OMAP4430 Multimedia Device

Silicon Errata

Literature number: SWPZ009A

Revision Initial 2010, October 22
Revision A 2010, December 21

Figure 2.1. MIPI DSI 1.00 (Implemented) - Video Mode Interface Timing: Nonburst Transmission With Sync Start And End.

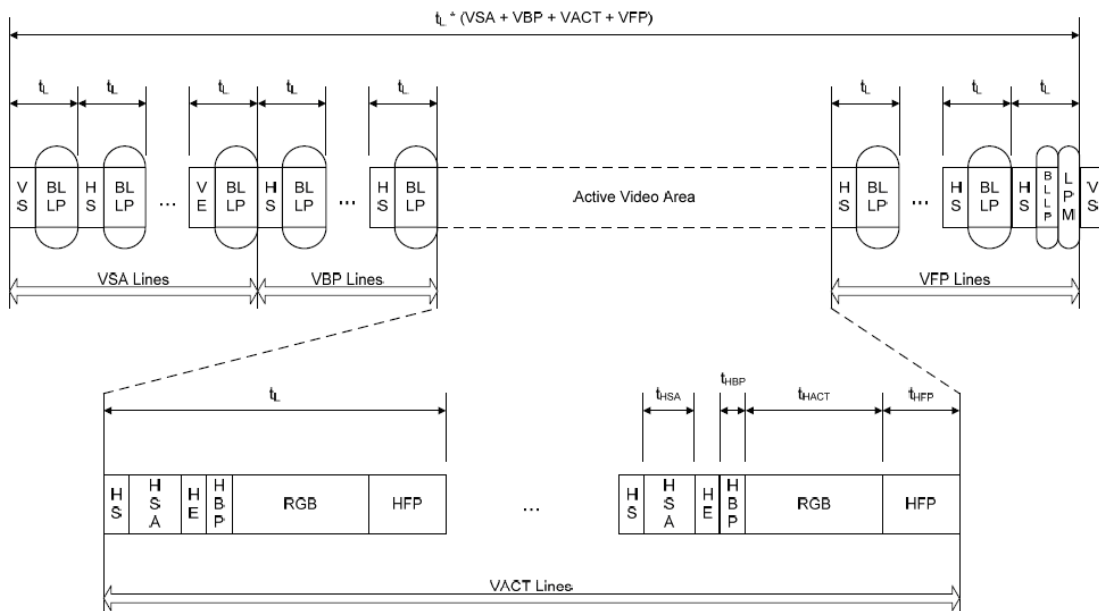
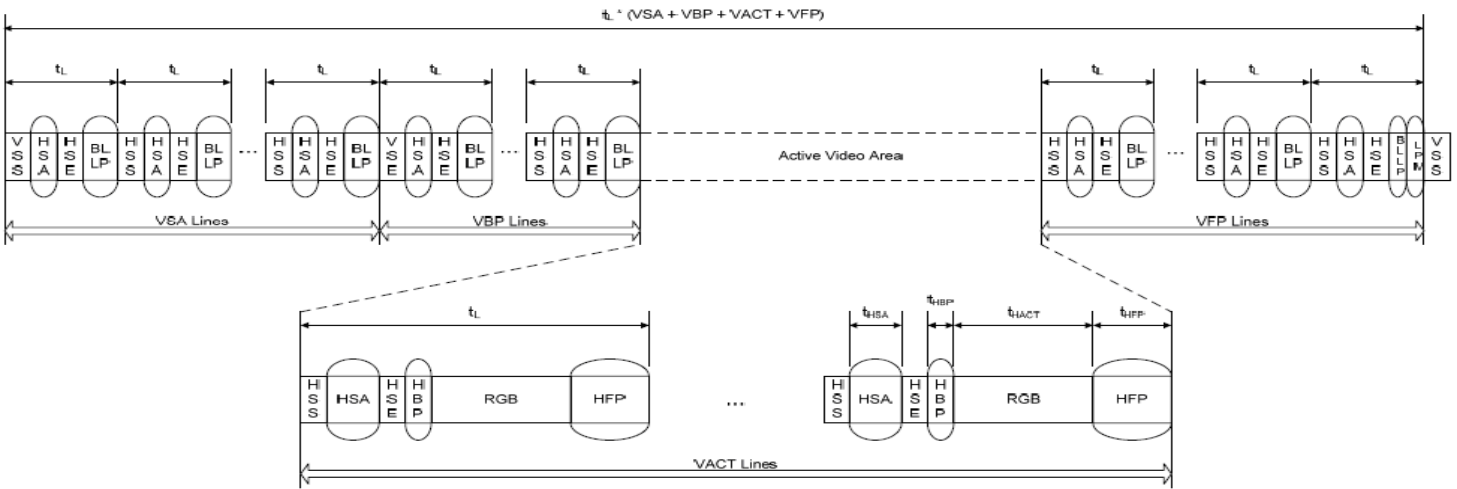
Figure 2.1 represents actual implementation and Figure 2.2 represents MIPI DSI ver. 1.01 specification.
